THE MARYLAND-NATIONAL CAPITAL PARK AND PLANNING COMMISSION  
Office of the Chairman, Montgomery County Planning Board

**DATE:** ~~October 16, 2003~~ February 13, 2004  
**TO:** Montgomery County Planning Board  
**VIA:** Joe R. Davis, Chief *JRD*  
Michael Ma, Supervisor  
Development Review Division  
**FROM:** Wynn E. Witthans *W*  
Planning Department Staff  
(301) 495-4584  
**REVIEW TYPE:** Final Water Quality Plan and Site Plan Review  
**APPLYING FOR:** Approval of 90,009 square feet on 11.40 acres  
**PROJECT NAME:** Traville Parcels I and J  
**CASE #:** 8-03012  
**REVIEW BASIS:** Div. 59-D-3, Montgomery County Zoning Ordinance for Site Plan  
Section 19-64 for Final Water Quality Plan  
**ZONE:** MXN  
**LOCATION:** Shady Grove Road 1,500 east of Silver Bell Terrace  
**MASTER PLAN:** Potomac and Vicinity  
**APPLICANT:** Willco Construction  
**FILING DATE:** November 1, 2002  
**HEARING DATE:** ~~October 23, 2003~~ February 19, 2004

**FINAL WATER QUALITY APPROVAL FOR SPECIAL PROTECTION AREA**

SITE PLAN

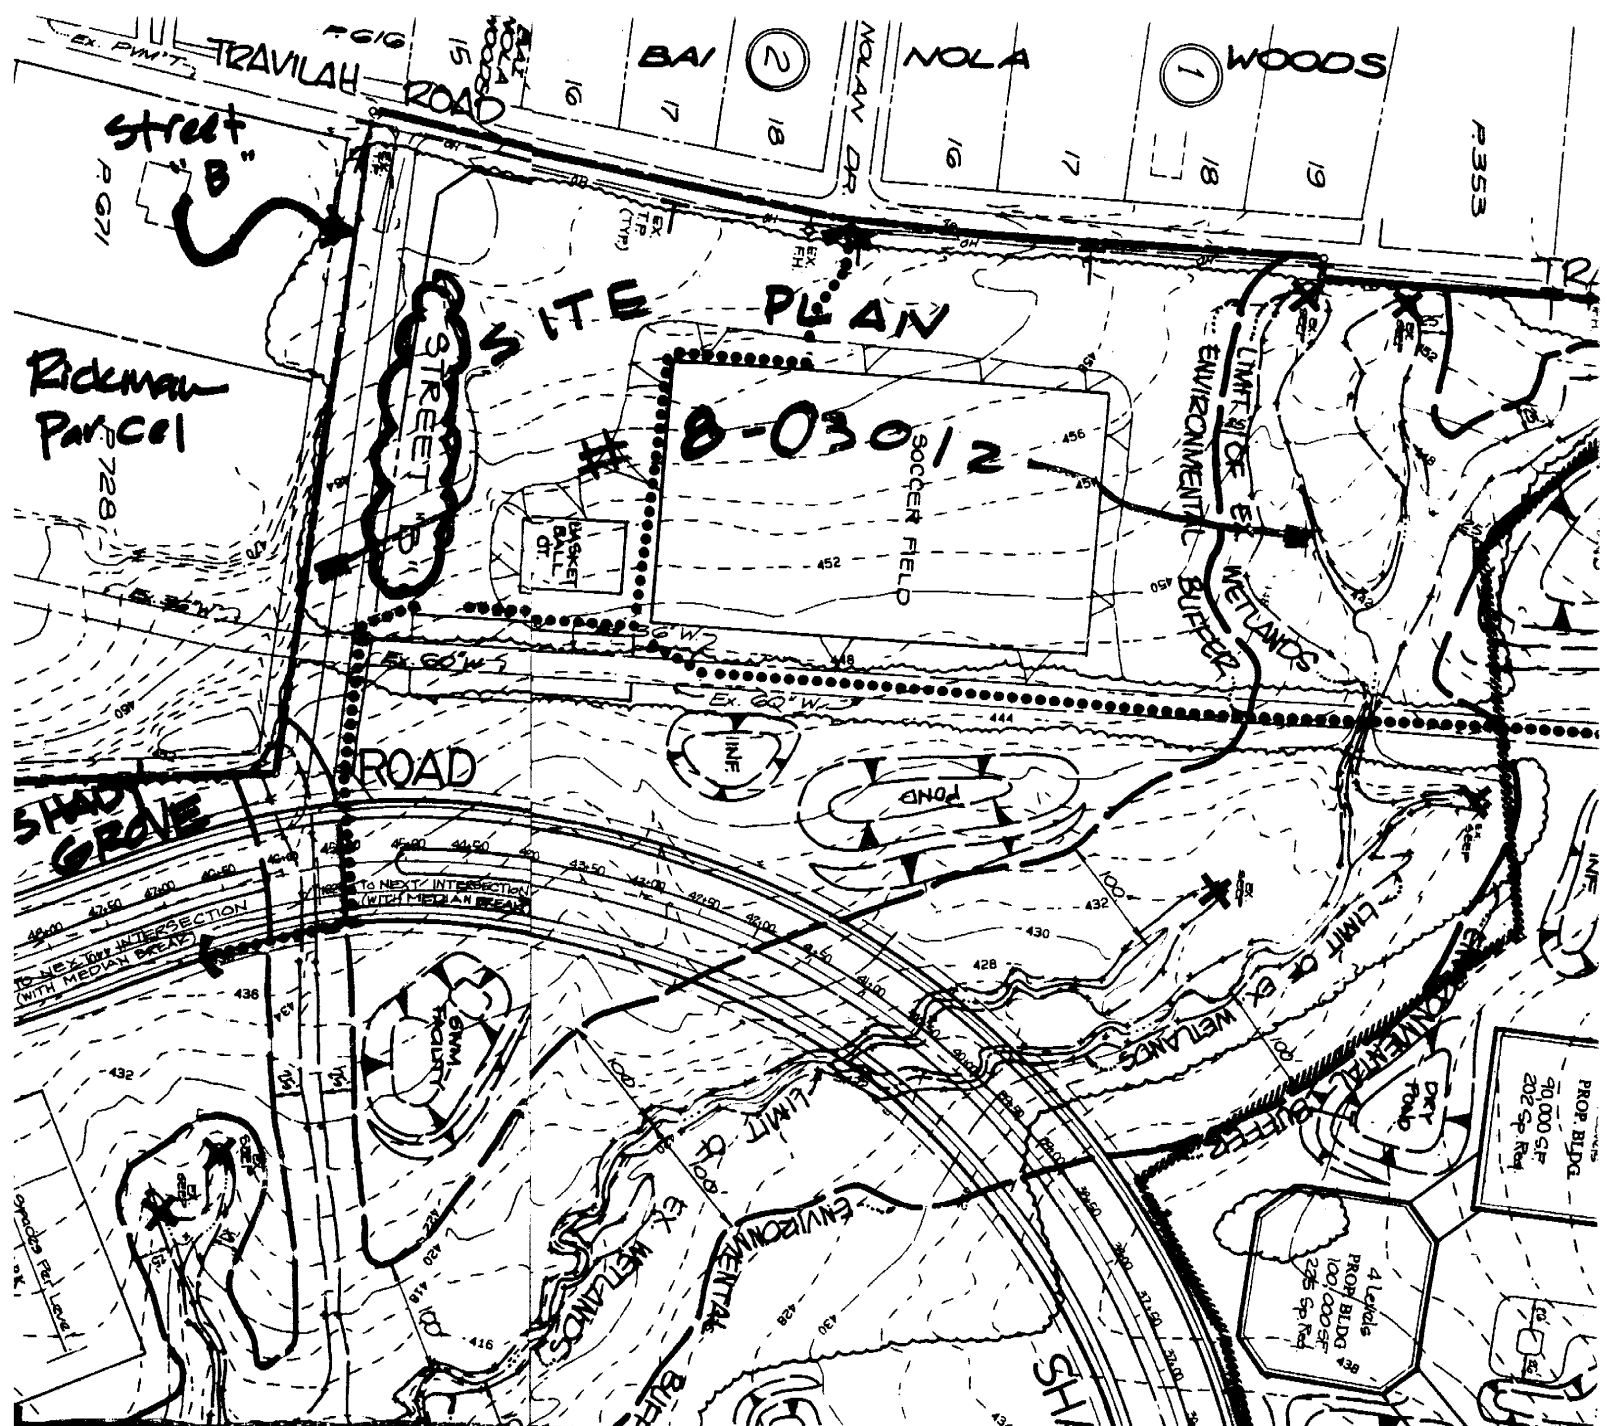
The Preliminary Plan Approval #1-97022 approved on September 11, 1997 showed a road "B" located immediately adjacent to the Rickman Parcel at the edge of the Traville site. Road "B" was relocated during the diagrammatic plan and site plan reviews because later in-depth study showed the water line (a 60" subsurface trunk line traversing the site adjacent to Shady Grove Road) created an insurmountable obstacle to locating the road in its current location. The road was relocated to a more interior portion of Parcels I and J in order to clear the grade.

Subsequent to the Preliminary Plan and the Diagrammatic Plan approval for Traville, the Shady Grove Master Plan was amended. It now recommends that access to the Rickman parcel, south west of the Traville diagrammatic plan area, be allowed via Shady Grove Road. This could be achieved with two routes :one through Parcel "K" and the second through the proposed site plan. See Master Plan discussion ahead.

Parcel "K," is an intervening piece of land between the Rickman parcel and Shady Grove Road. Parcel "K" partially contains the rare threatened and endangered species - the krigia dandelion - but has adequate space to make a connection to the Rickman parcel. Initially Parcel "K" was part of this site plan but was later dropped from the application.

The second opportunity for the Rickman parcel access would be through this site plan. An internal driveway has been designed that would allow for this interparcel connection. DPS and DPWT have favorably reviewed the internal driveway intersection with the connector street within the proposed site plan.

Staff has set up a series of meetings in an attempt to foster a resolution of the issue. ~~They were not successful.~~ Staff maintains that the Preliminary Plan shows an alignment that allows for the connection that can be accomplished with this site plan and the internal drive. The connection is not exactly as shown in the Preliminary Plan (due to physical constraints) but it accomplishes the same goal.

The secondary point of access would more evenly distribute the trips on the site between Travilah Road and Shady Grove Road. Inter-parcel connection in this area is a concept used in many of the residential site plans in this area with great success given the lack of intersecting roads to Travilah and Shady Grove Roads. The Master Plan recommendation that the Rickman parcel orient to Shady Grove Road is incumbent on having access to that same street. Additionally it is more desirable to have the Rickman parcel presence on Shady Grove Road, a predominately business street (to the north) rather than Travilah Road, a predominately residential street.

Ultimately they reached agreement on access through Parcel "K", they updated the impervious are chart for the Traville subdivision and submitted to staff a copy of their agreement indicating the condition requiring the connection would be met. Their letters of agreement are attached.

Staff will be pleased to recommend the site plan for approval during the Planning Board's February 19, 2004 hearing.
